9-19-17_Strip_Seal_Assembly_Shop_Drawings__Approved as Noted.pdf

LOCATION — VT-15A OVER LAMOILLE RIVER
BRIDGE — 1
PROJECT NO. — BRS 0240(3)S/STP HES 030-2(28)
PROJECT NAME — MORRISTOWN
P.O. NO. — K1617
DESIGNER — T.Y.LIN INTERNATIONAL
CUSTOMER — WINTERSET, INC.

DESCRIPTION: SSPA STANDARD DETAILS LAMOILLE COUNTY, VERMONT

SECTION THRU 'SSPA' EXP. JOINT

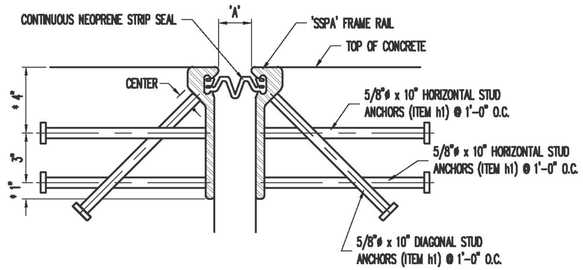
Per special provision:

Steel portions of the expansion device shall be galvanized. Galvanizing on the metal surfaces in direct contact with strip seals shall be lightly sandblasted to a dull gray appearance in order to promote a high strength bond between the seal and mating surface, and for smoothness for installation purposes. Alternately, this galvanized surface may be prepared to the manufacturer's published recommendations for installation and bonding of seals.
